TOWN OF KITTERY

Planning Review Notes March 14, 2024

ITEM 1—120 Route 1—Major Site Plan — Final Review

SUBJECT: Response to CMA Engineers, Inc. Comments – 11/6/2023
Proposed Hotel Development
Tax Map 14, Lots 10, 12 & 12A

GENERAL NOTES
SCALE: NOT TO SCALE
PROJECT NO: NEX-2200380
2 OF 18

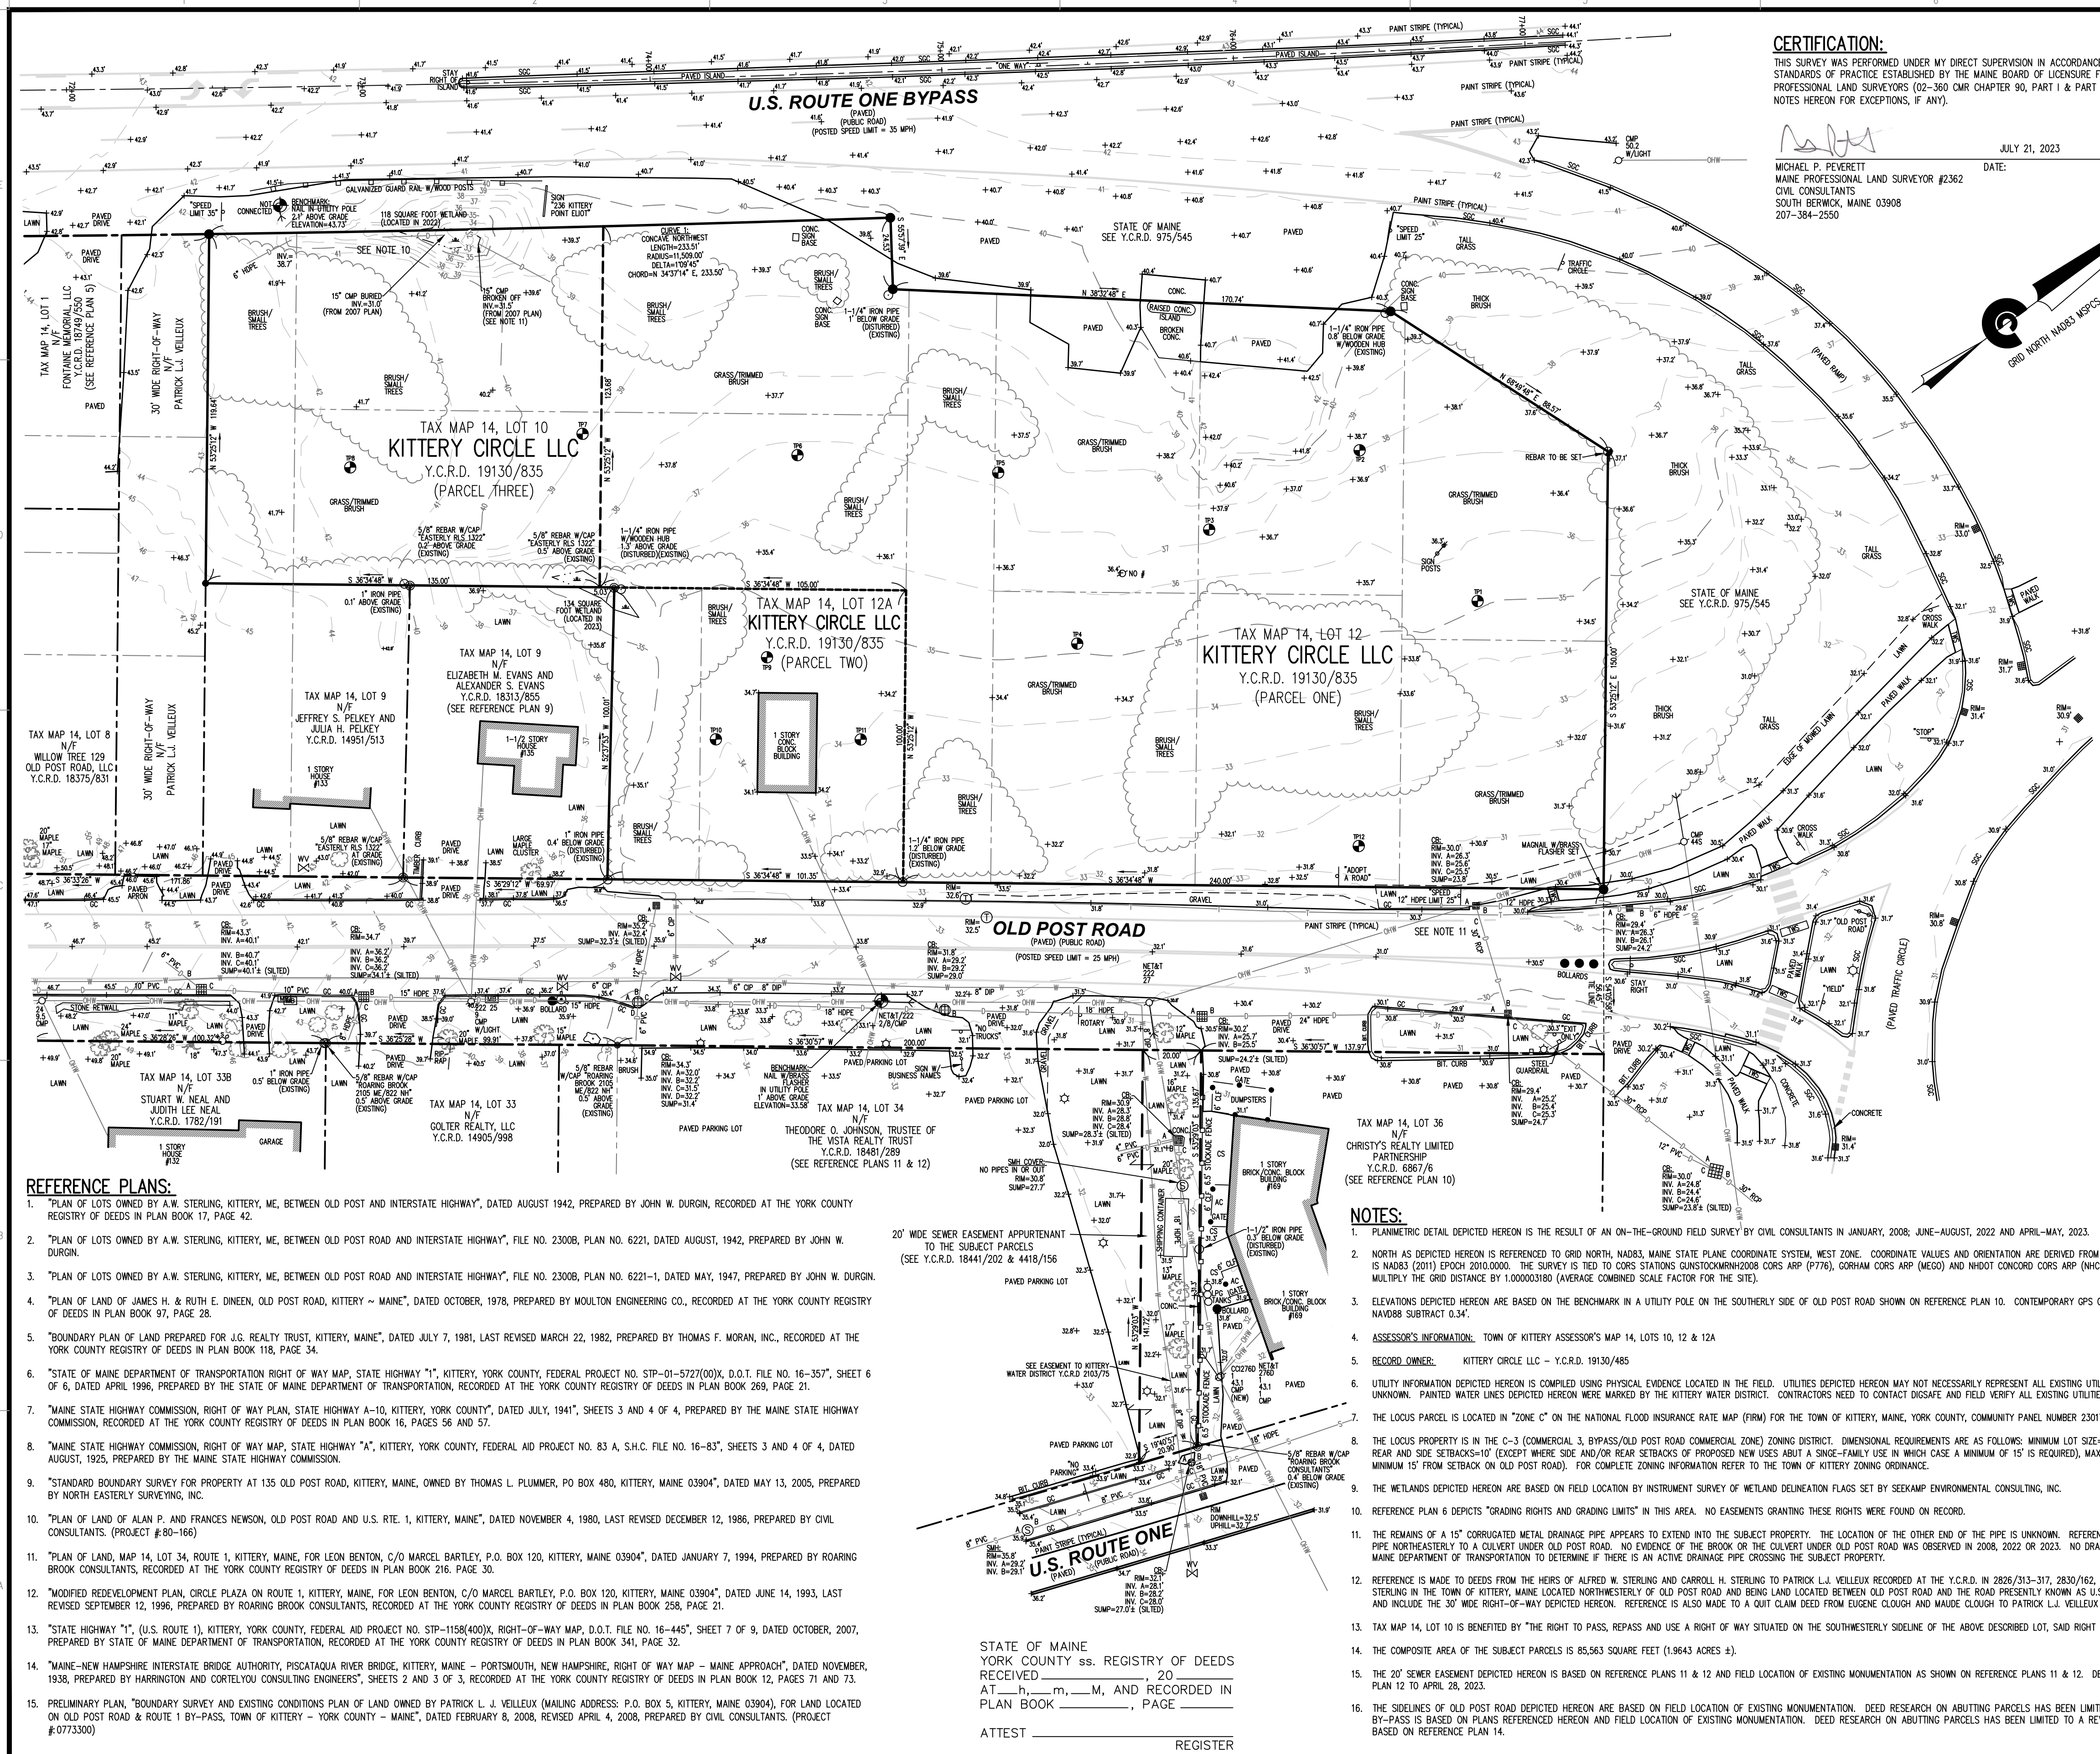
1. Under site plan notes, note 17 lists two requested modifications from the planning board. Has the applicant applied for waivers and or variances? What is the requested reduction for the planter strip? Sheet 6 indicates a modification for the total number of parking spaces is also desired-this should be included in Note 17.

6. Temporary Erosion Control Measures Note 13 references "construction entrances shown on this plan". Please update to Sheet 10.

Sheet 10 – Sewer Connection Plan

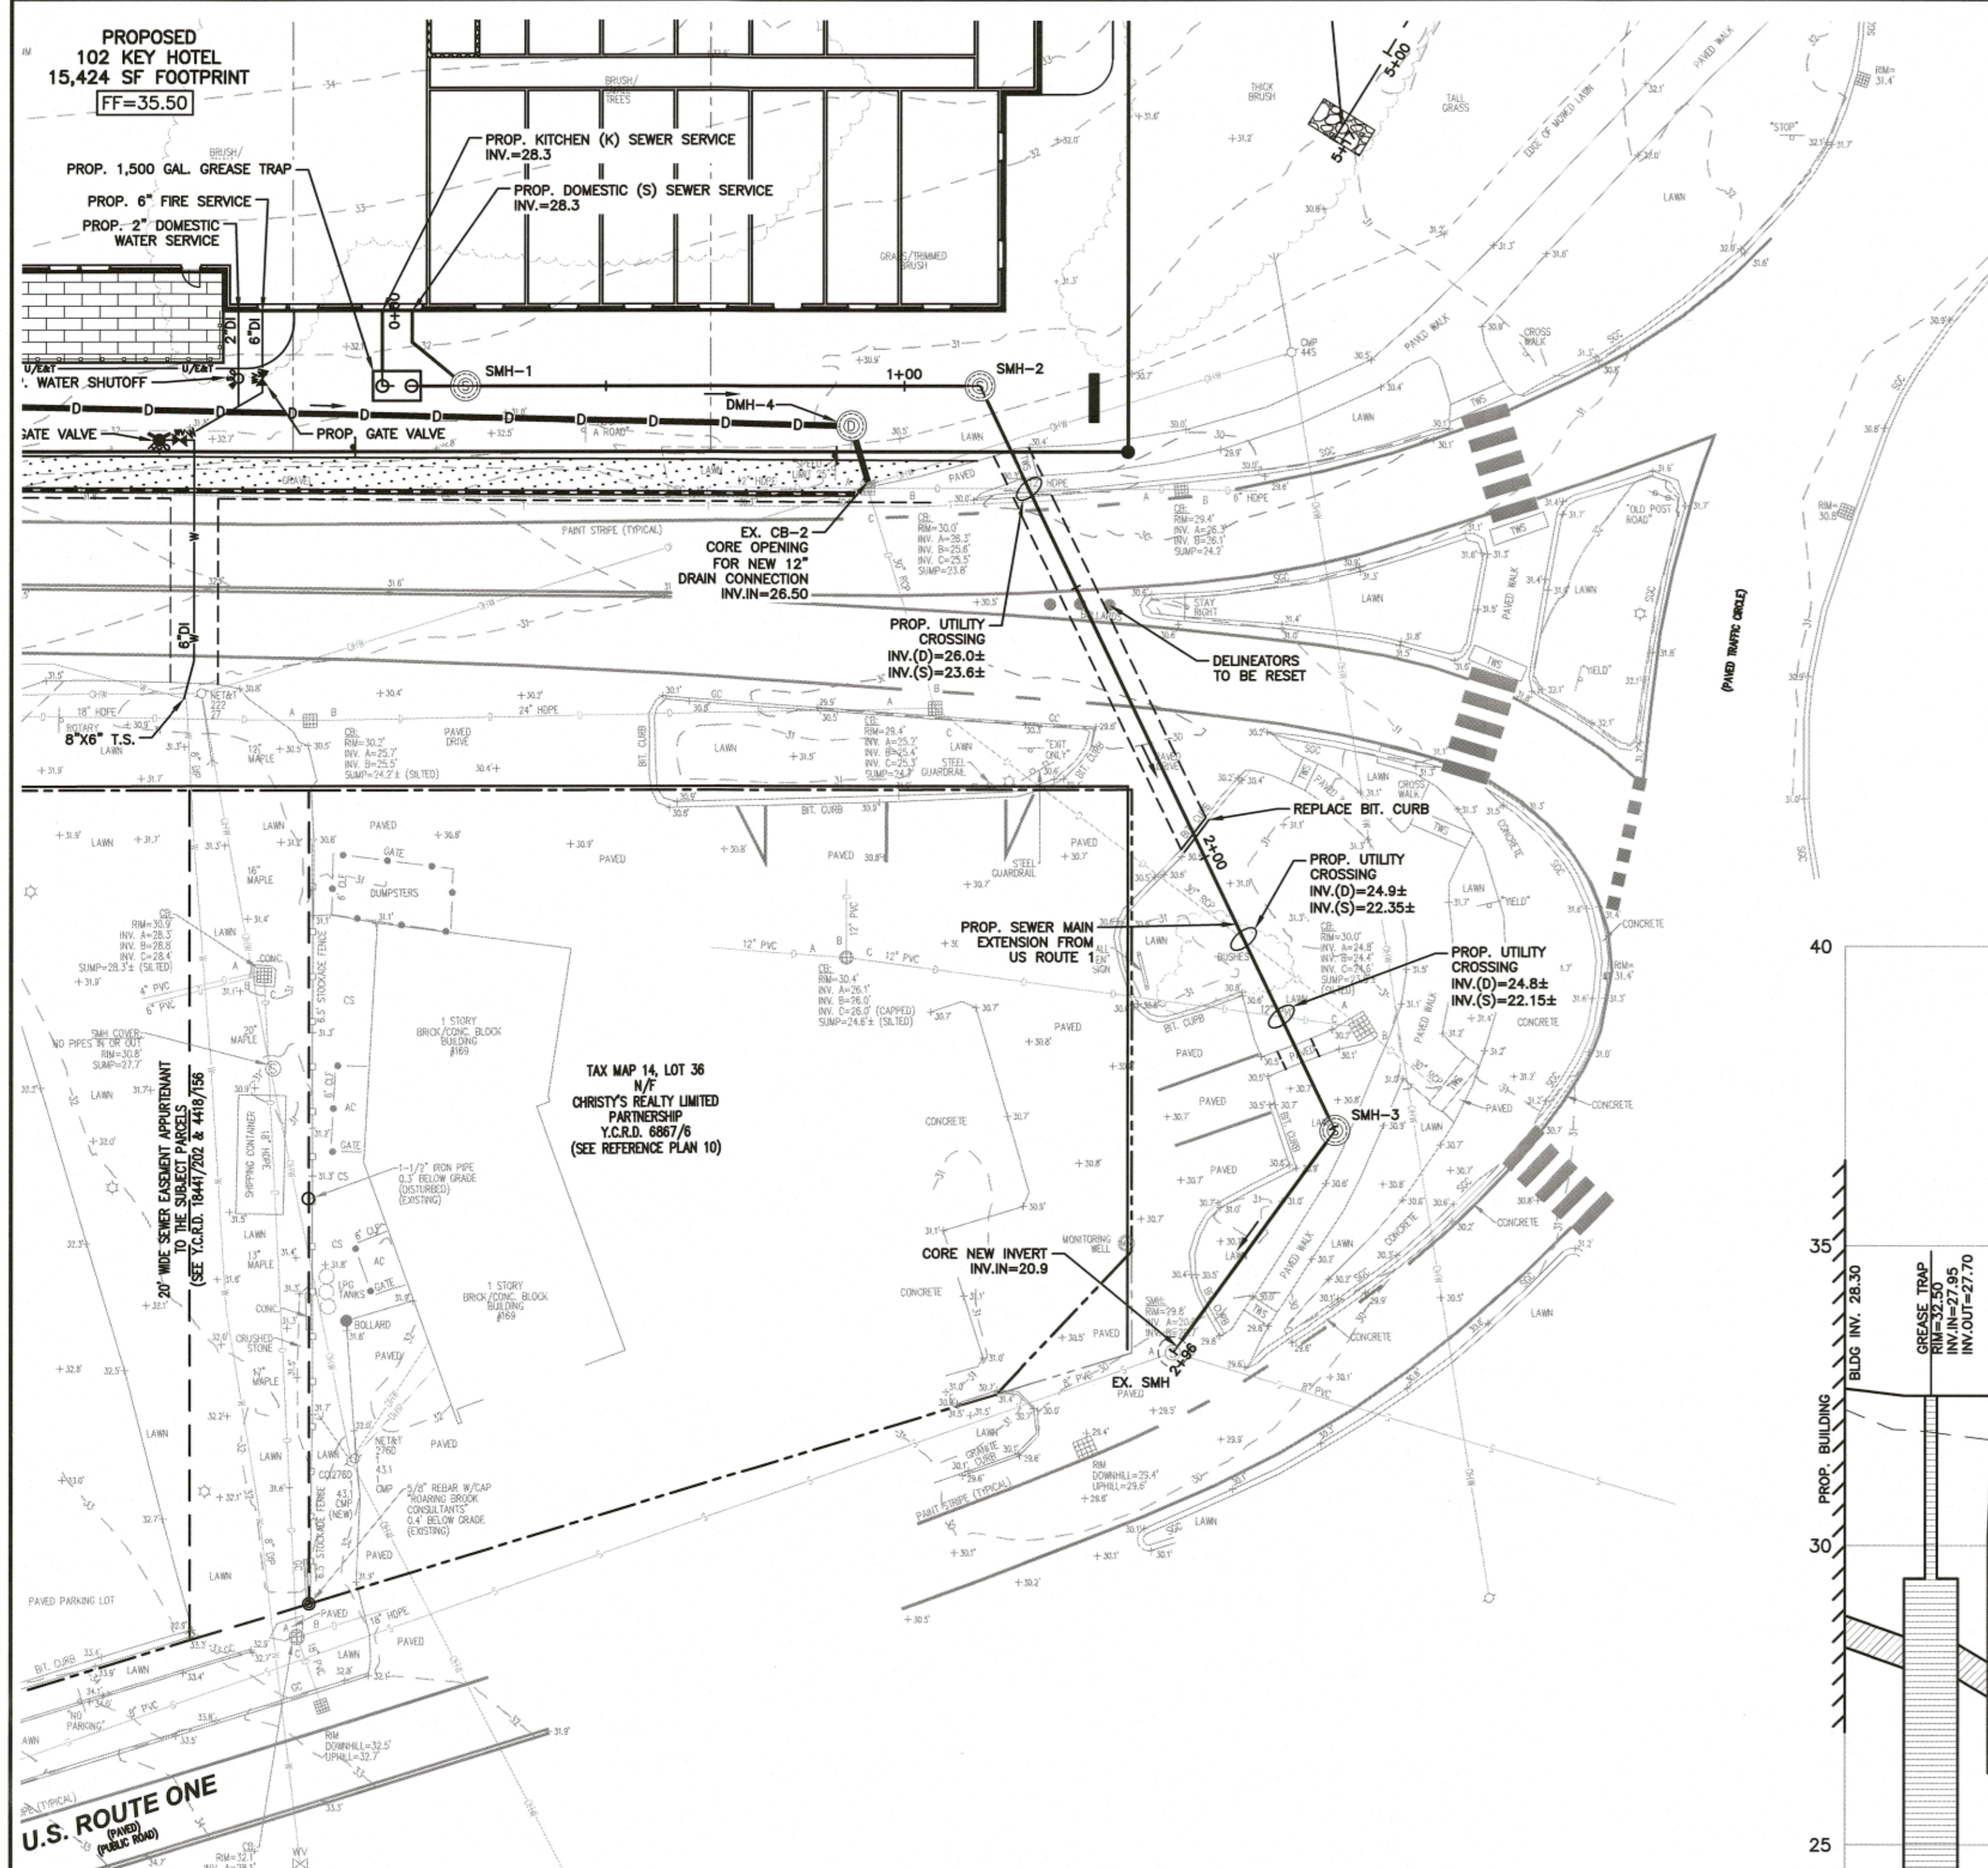
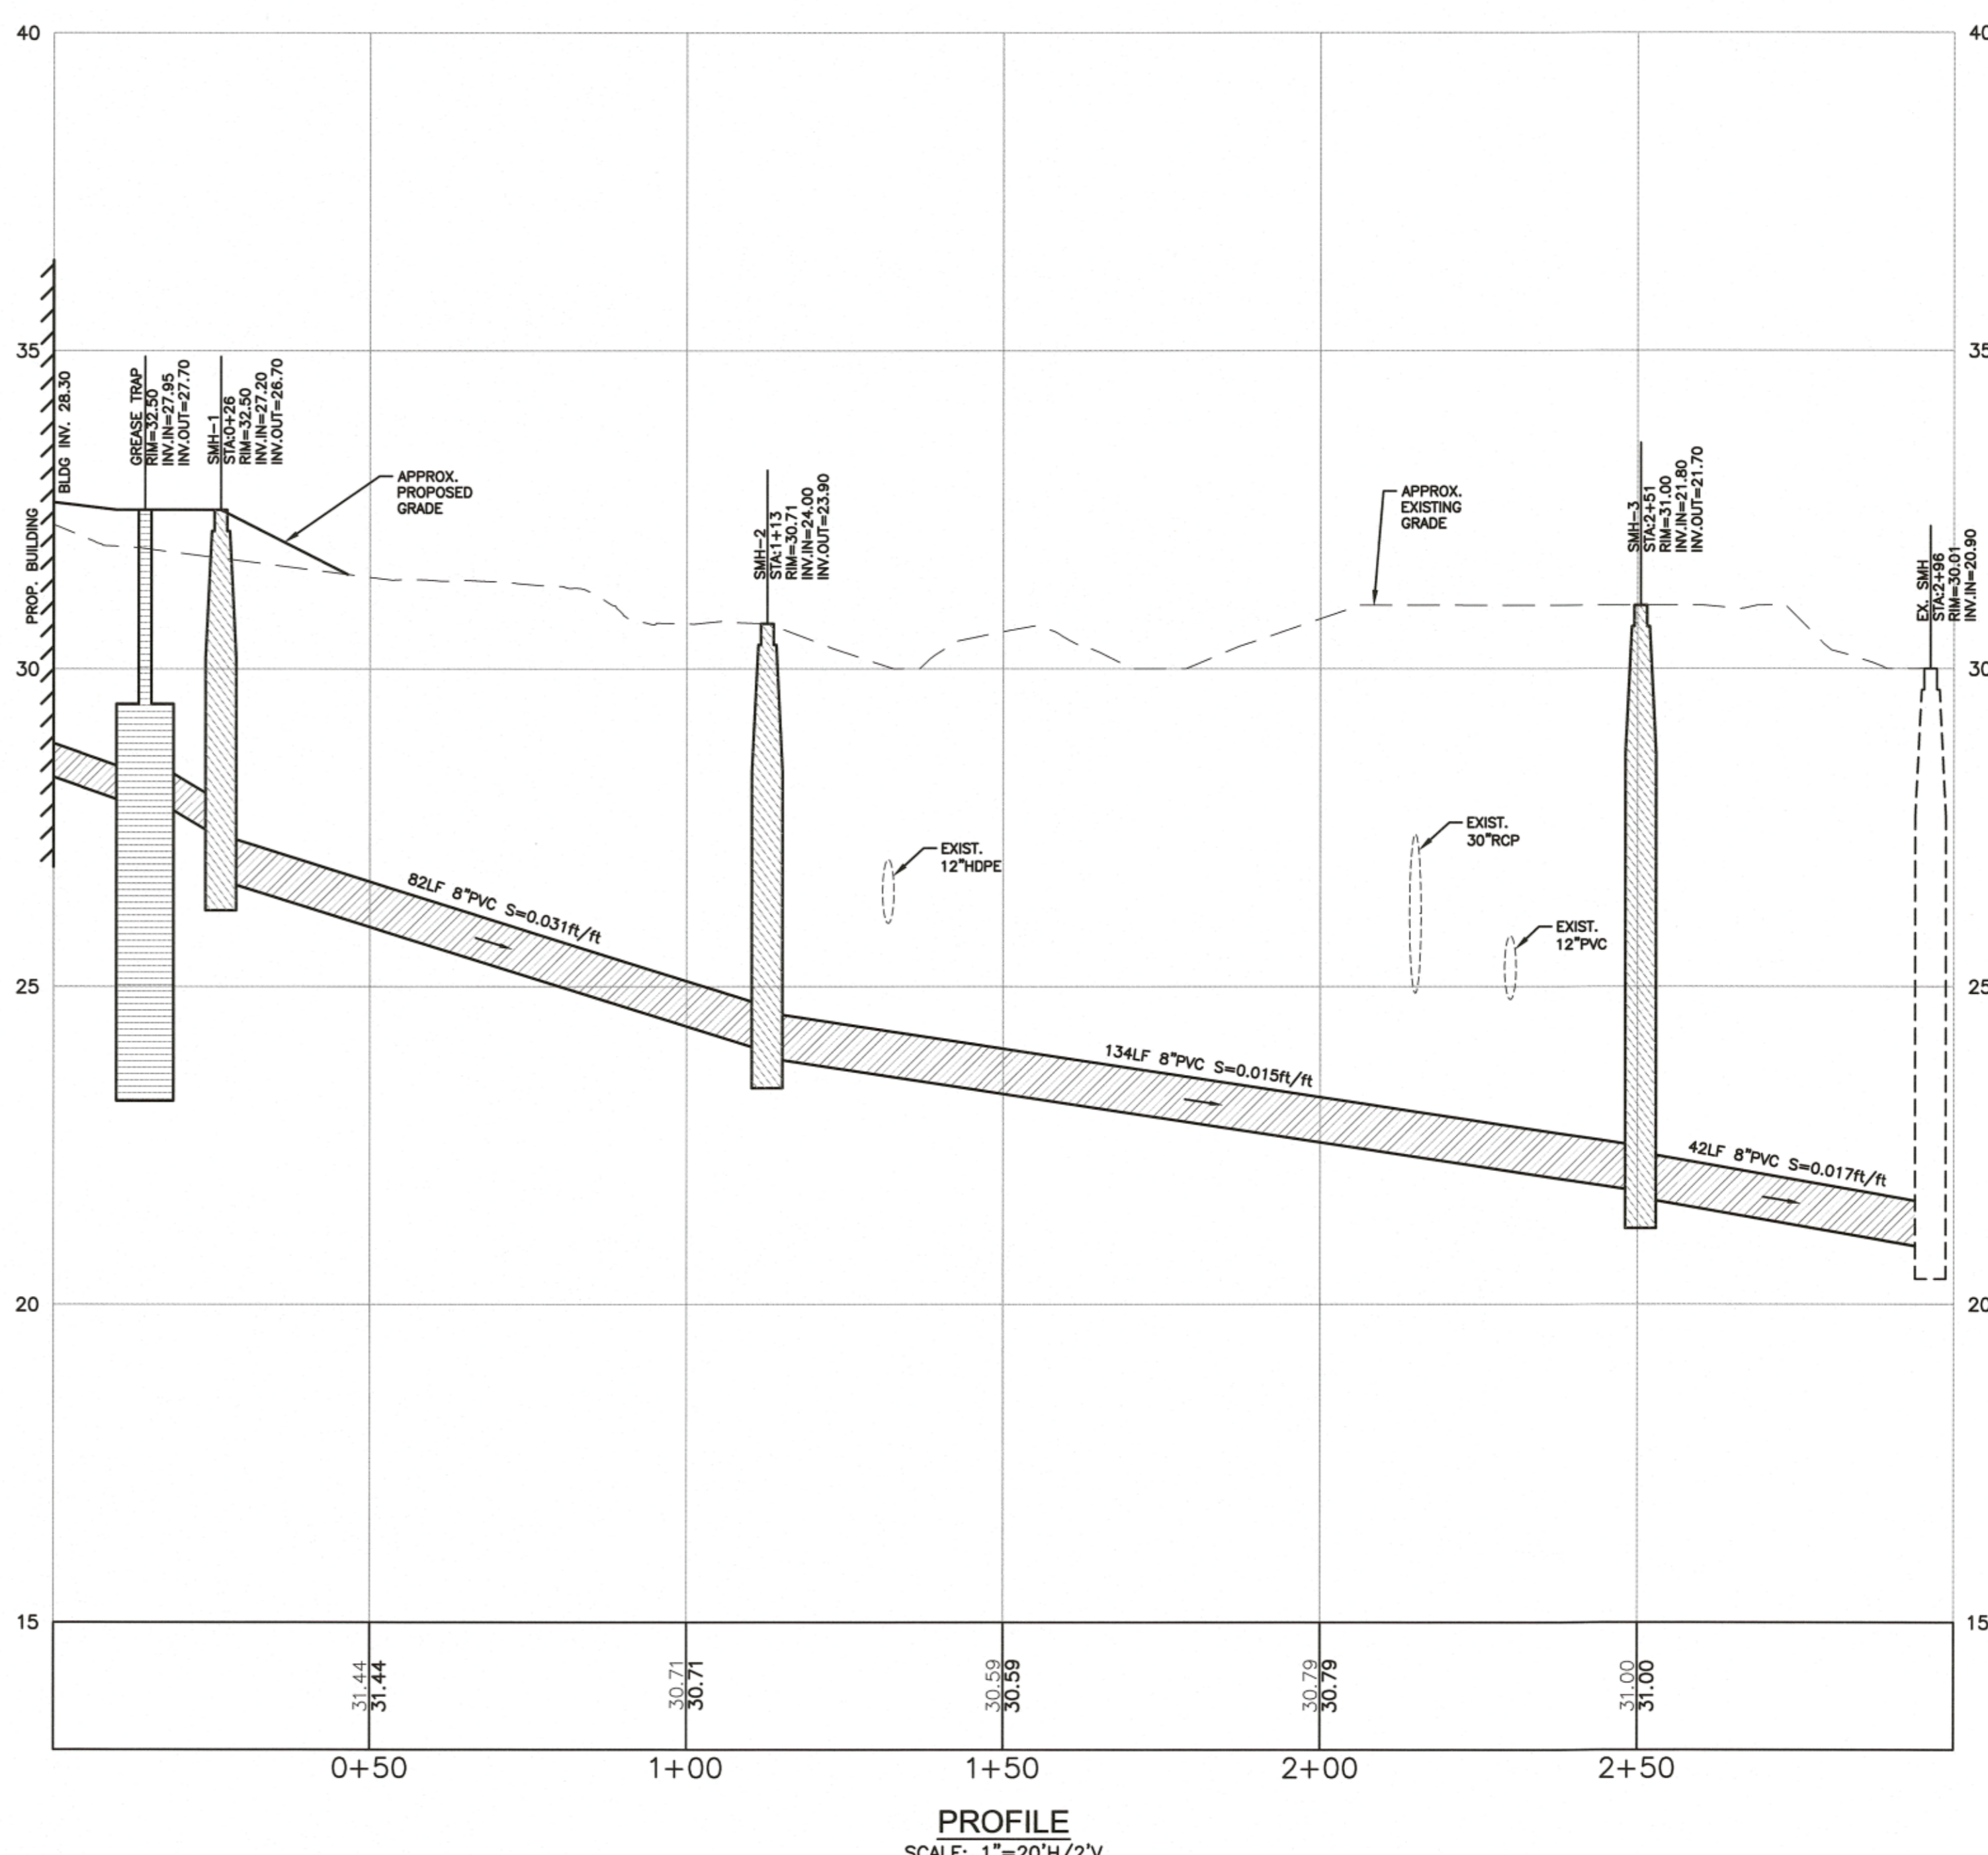
- 1) Has the condition of the existing sewer manhole to be cored been assessed?
- 2) A cleanout should be provided for the sewer service. The applicant indicates that a cleanout has been added but none is shown. We note that a detail has been added to Sheet 16.
- 3) Has the sewer design evaluated alternatives to a bend in the service? A cleanout at this location makes sense. The applicant indicates that a cleanout has been added but none is shown. We note that a detail has been added to Sheet 16.
